## PIC24FJ256DA210 Family Silicon Errata and Data Sheet Clarification

The PIC24FJ256DA210 family devices that you have received conform functionally to the current Device Data Sheet (DS39969B), except for the anomalies described in this document.

## Data Sheet Clarifications

The following typographic corrections and clarifications are to be noted for the latest version of the device data sheet (DS39969B):

**FIGURE 2-3 FREQUENCY vs. ESR PERFORMANCE FOR SUGGESTED VCAP**

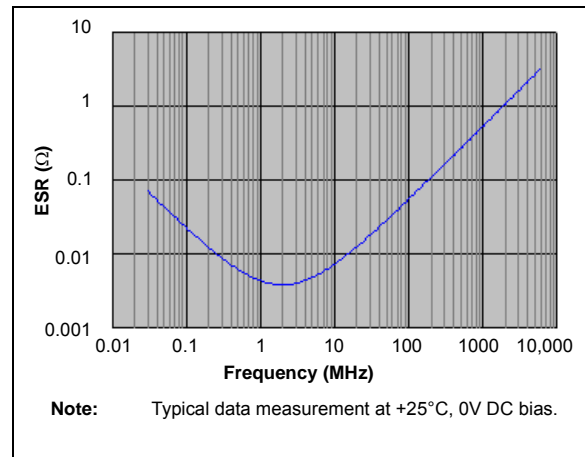
Section 2.4 “Voltage Regulator Pins (ENVREG/DISVREG and VCAP/VDDCORE)” has been replaced with a new and more detailed section. The entire text follows:

When the regulator is enabled, a low-ESR ( $< 5\Omega$ ) capacitor is required on the VCAP pin to stabilize the voltage regulator output voltage. The VCAP pin must not be connected to VDD and must use a capacitor of 10  $\mu\text{F}$  connected to ground. The type can be ceramic or tantalum. Suitable examples of capacitors are shown in Table 2-1. Capacitors with equivalent specifications can be used.

Designers may use Figure 2-3 to evaluate ESR equivalence of candidate devices.

The placement of this capacitor should be close to VCAP. It is recommended that the trace length not exceed 0.25 inch (6 mm). Refer to Section 30.0 “Electrical Characteristics” for additional information.

**FIGURE 2-4 DC BIAS VOLTAGE vs. CAPACITANCE CHARACTERISTICS**

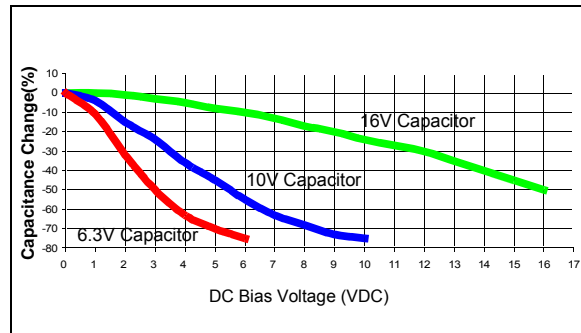
In addition to temperature tolerance, the effective capacitance of large value ceramic capacitors can vary substantially, based on the amount of DC voltage applied to the capacitor. This effect can be very significant, but is often overlooked or is not always documented.

A typical DC bias voltage vs. capacitance graph for 16V, 10V and 6.3V rated capacitors is shown in [Figure 2-4](#).

When selecting a ceramic capacitor to be used with the internal voltage regulator, it is suggested to select a high-voltage rating, so that the operating voltage is a small percentage of the maximum rated capacitor voltage. For example, choose a ceramic capacitor rated at 16V for the 1.8V VCAP voltage. Suggested capacitors are shown in [Table 2-1](#).

**FIGURE 30-1: PIC24FJ256DA210 FAMILY VOLTAGE-FREQUENCY GRAPH (INDUSTRIAL)**

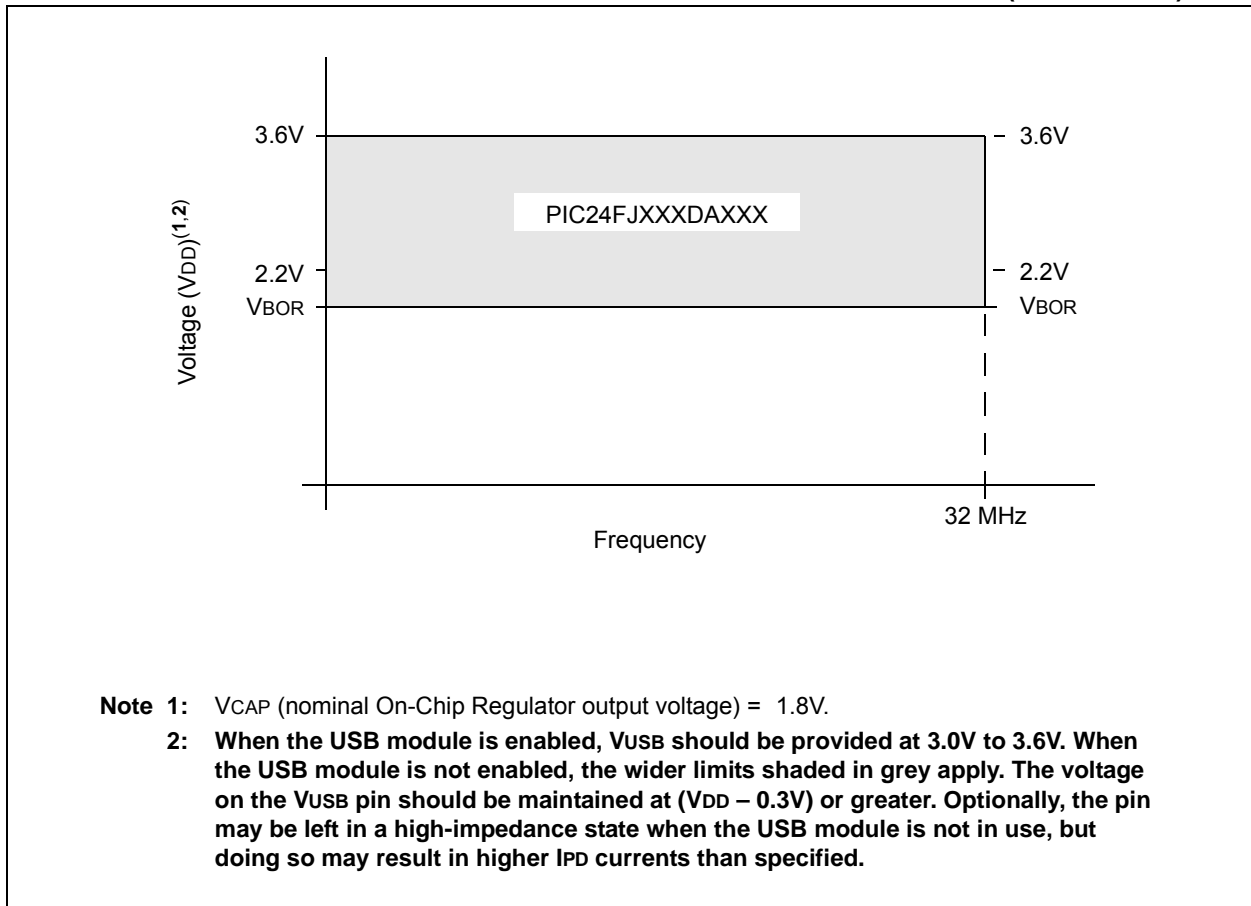
Figure 30-1 (“PIC24FJ256DA210 Family Voltage-Frequency Graph”) is amended by adding an additional footnote. The updated figure is shown below (changes in **bold**; bold in original removed for clarity).
